ADDENDUM NO. 2

UTILITY INFRASTRUCTURE IMPROVEMENTS
WAPPAPELLO TRAINING SITE
WAPPAPELLO, MISSOURI
PROJECT NO.: T2213-01

August 18, 2022

C-102

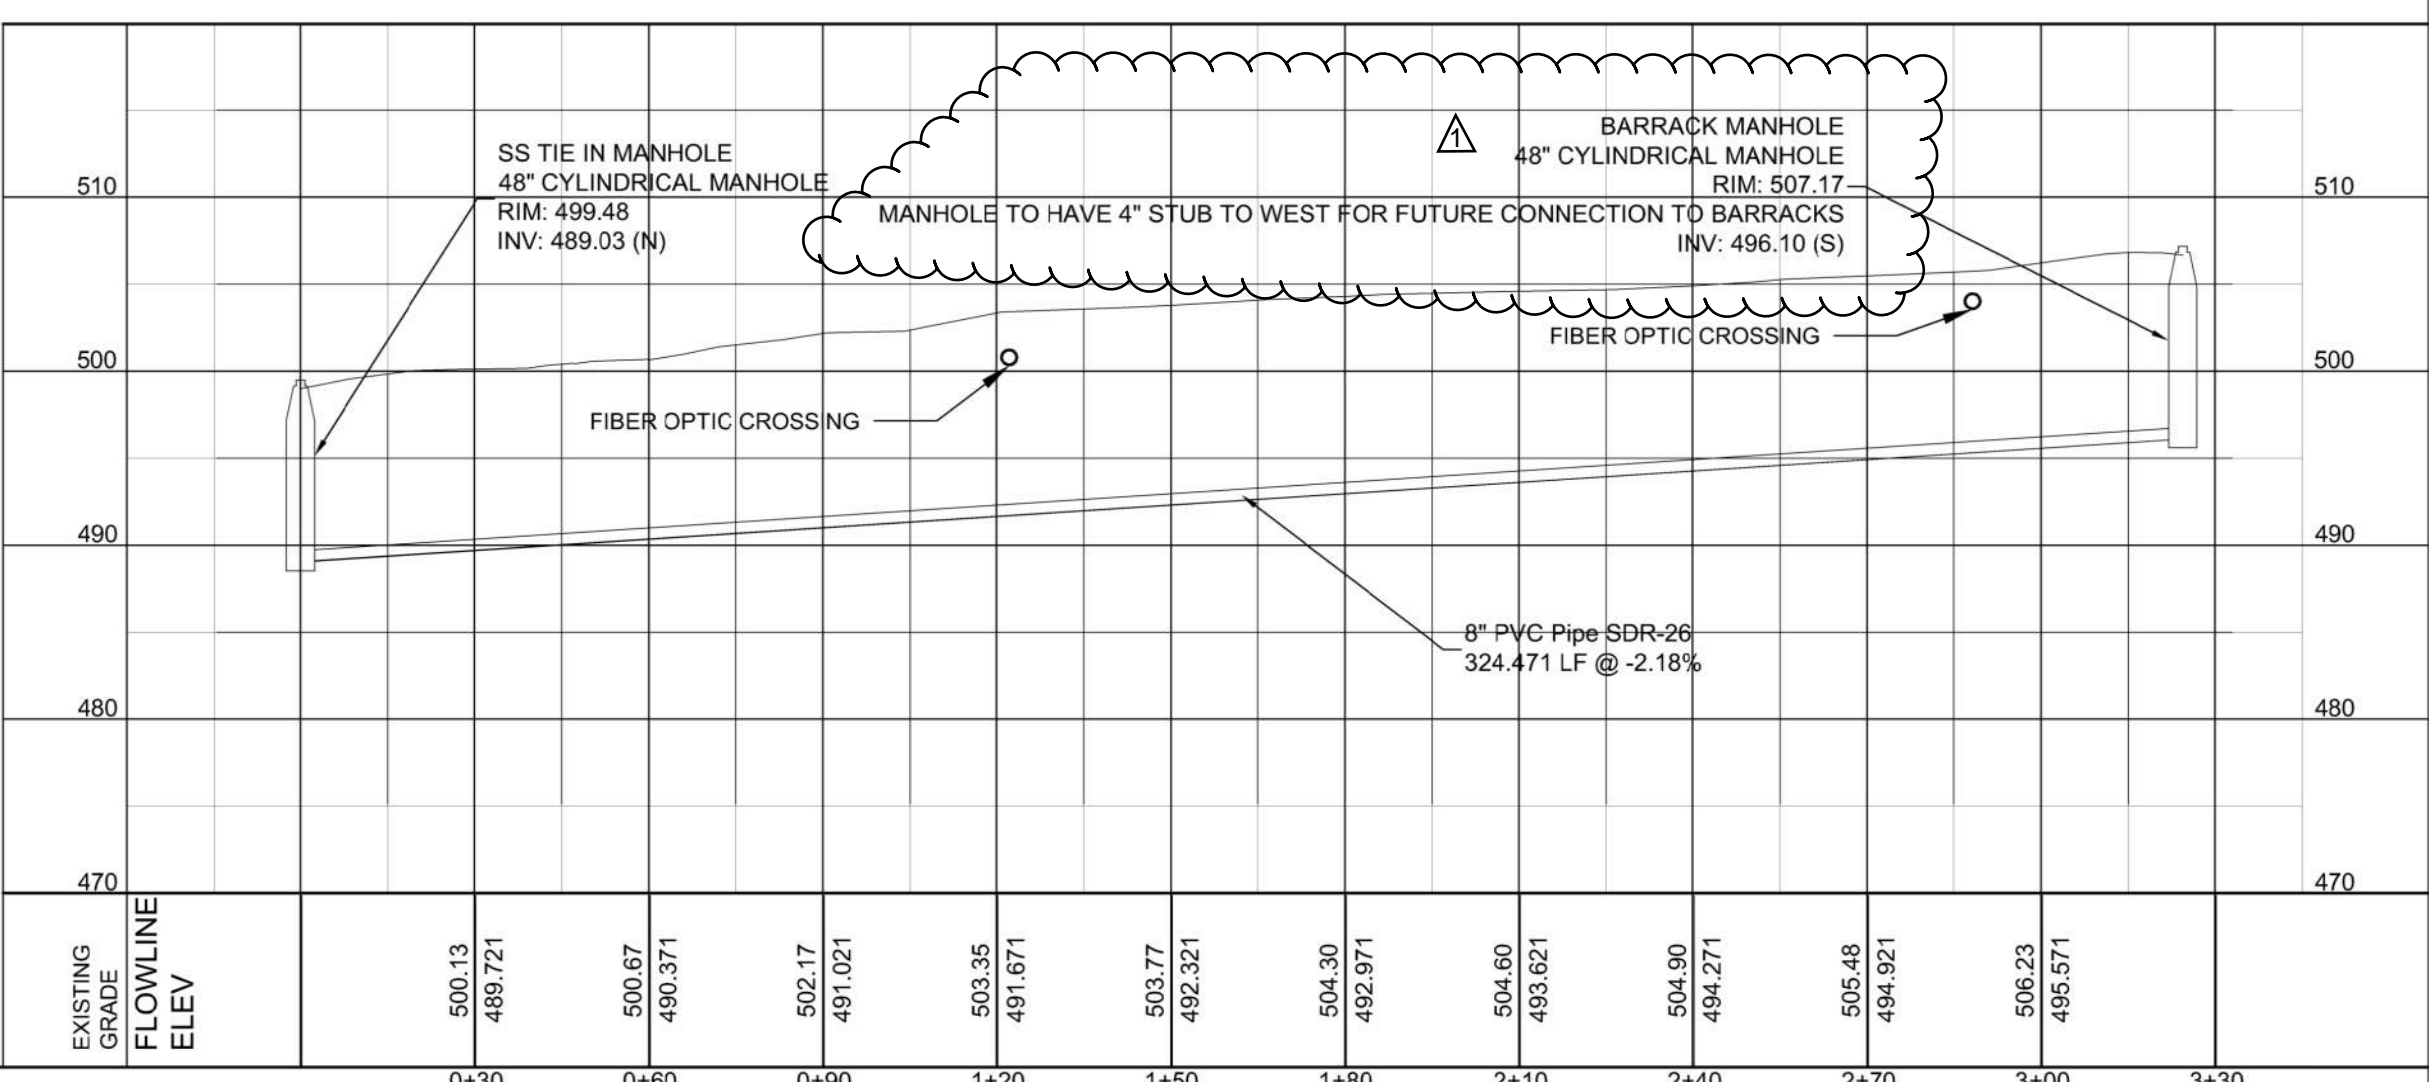
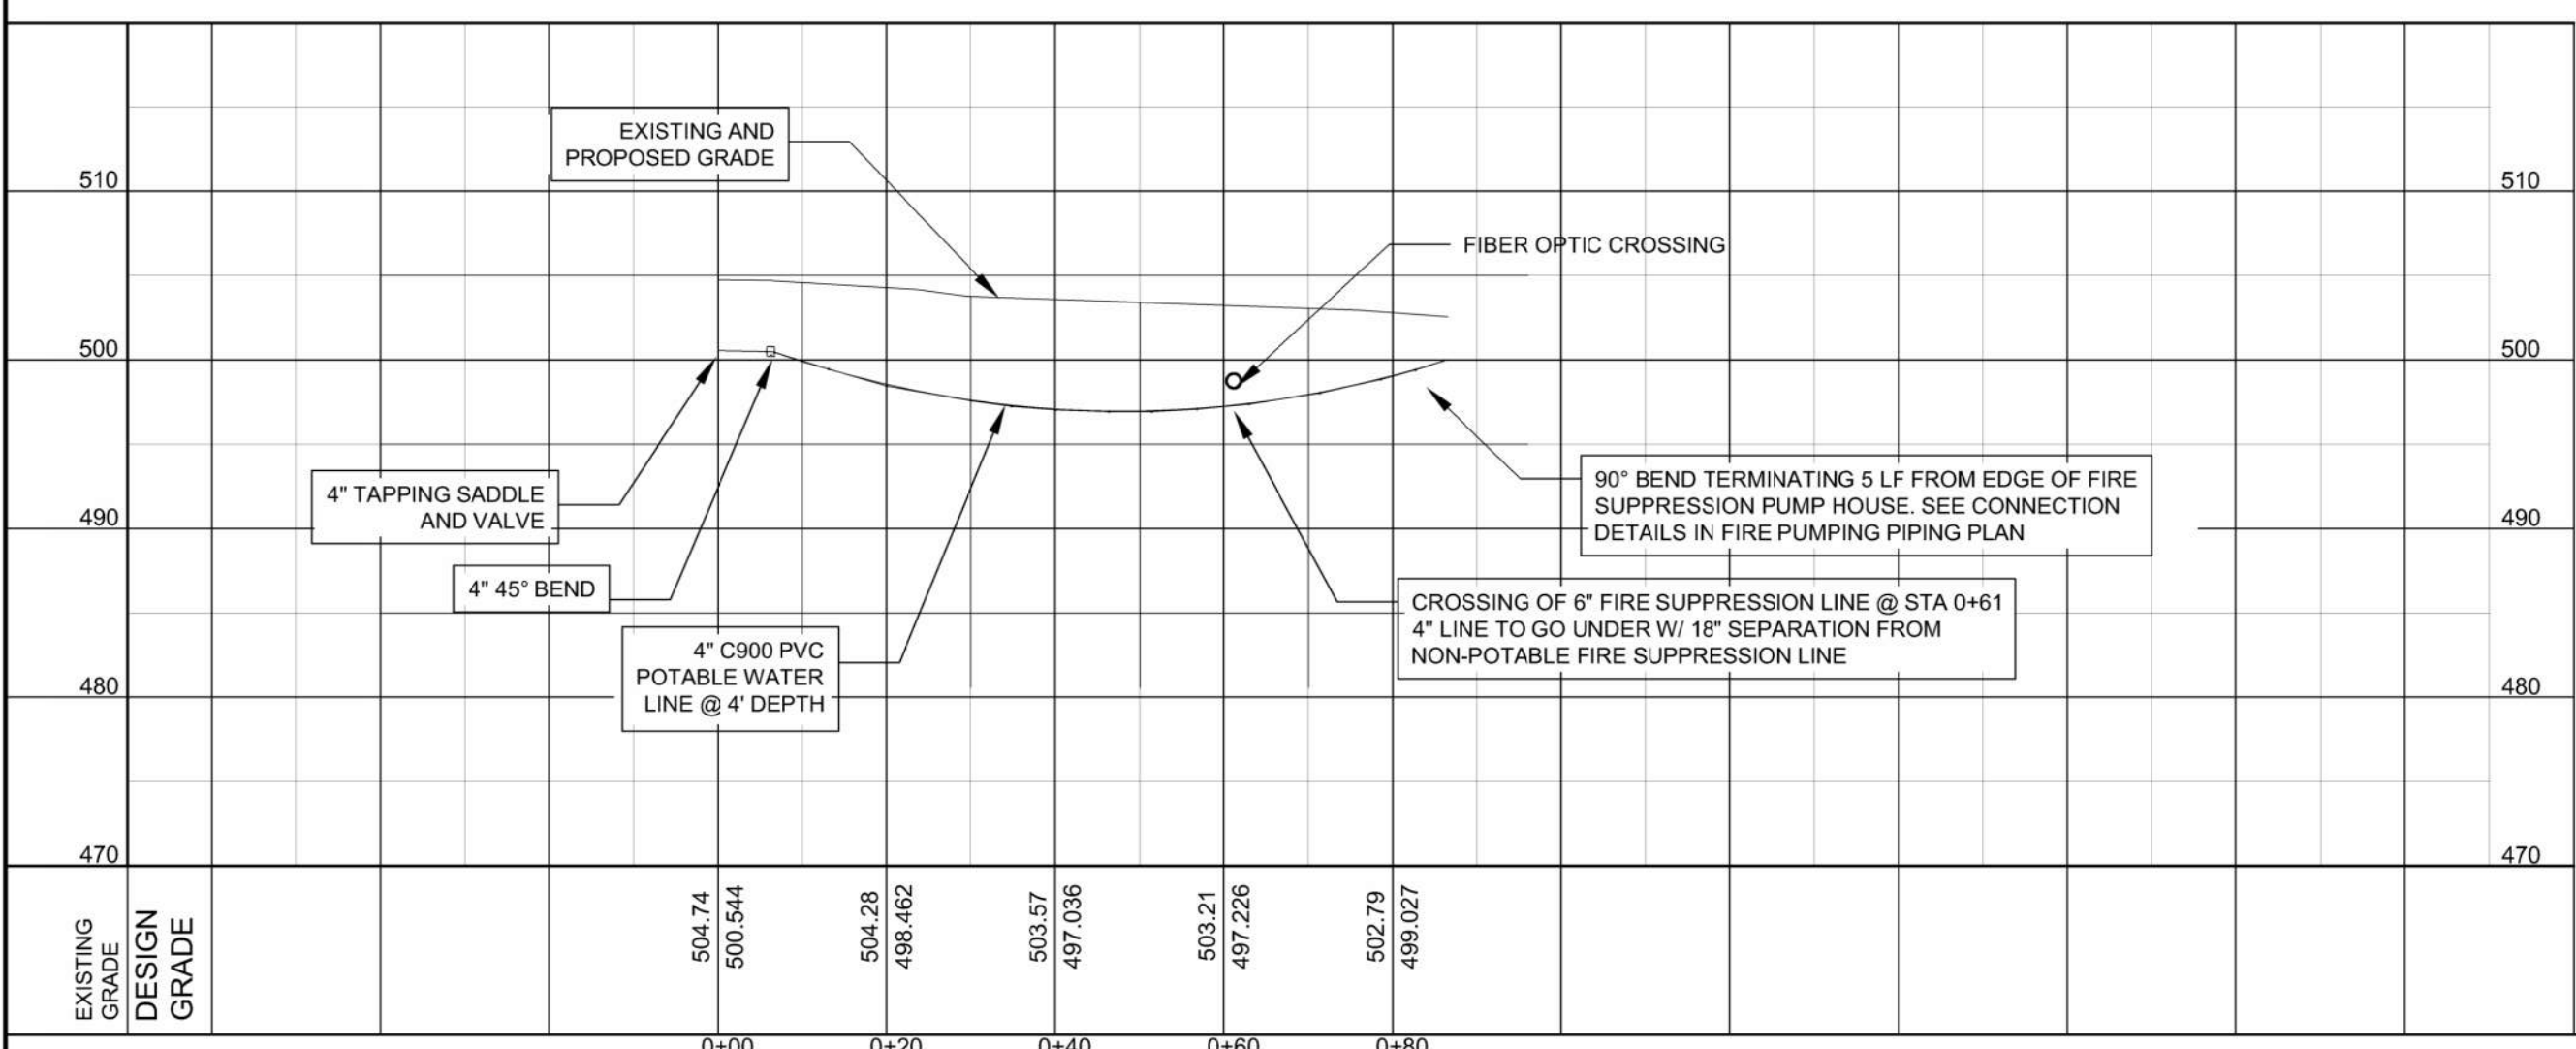
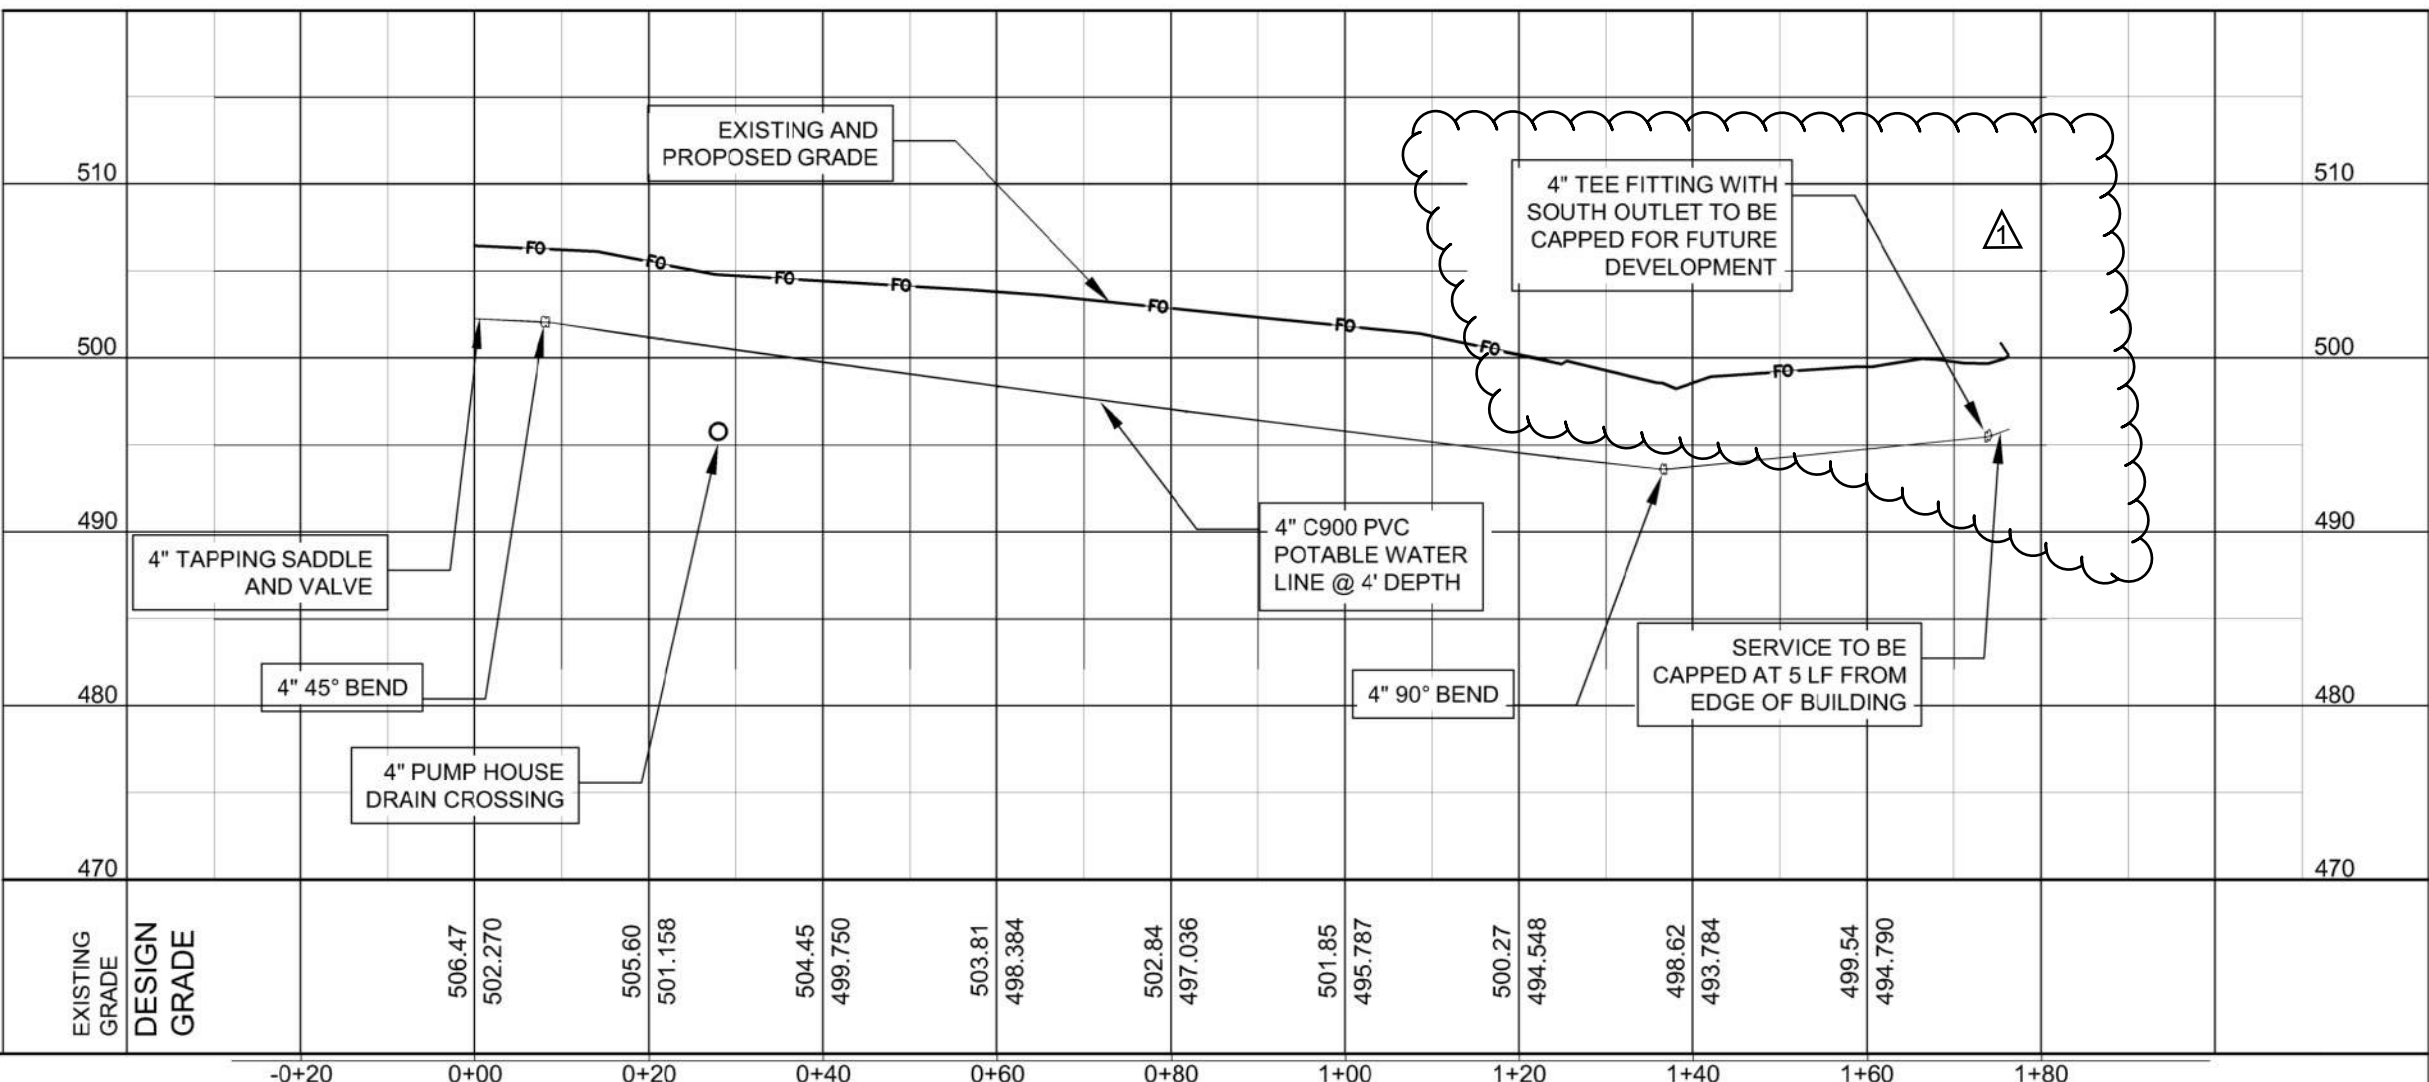
2. Sheet C102

ADD Note to profile at sanitary station 1+40 clarifying that aggregate backfill is required for full depth of trench at roadway crossing.

DELETE Notes requiring a flush hydrant and valving on the domestic water line.

ADD Note to require 4" sanitary stub on west side of the manhole at the proposed barracks building
